Re: Thunderbolt Wind Farm Noise Assessment - Review

L Huson & Associates Pty Ltd has been commissioned by the Friends of Kentucky Action Group to review the Thunderbolt Energy Hub – Stage 1 Environmental Impact Statement (EIS) dated March 2022 that was Prepared by Umwelt (Australia) Pty Limited on behalf of Neoen Pty Limited.

This peer review considers the assessment of predicted operational wind farm noise and compliance with the NSW Secretary's Environmental Assessment Requirements (SEAR) for the EIS.

Fig. 12-1 Frequency weighting A

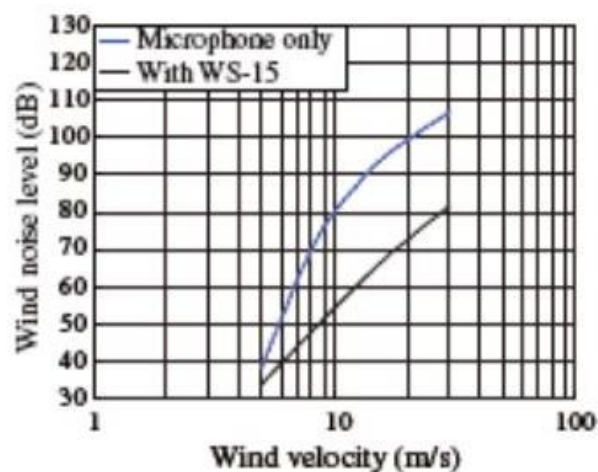
Extrapolating the local wind speed velocity to 4 m/s it is expected that wind generated artificial noise on the microphone is 30 dBA. Such influences on the measured Background noise measurements are required by SA 2009 to be addressed in the development application (EIS).

The Sonus report states that measured sound levels in local wind speed above 5 m/s were discarded but the report does not describe how the wind speed below 5 m/s affects the measured results. For equipment using the WS-15 wind screen it would be appropriate to correct measurements with local wind speeds around 4 m/s generating artificial noise around a level of 30 dBA, as described in SA 2009 as follows:
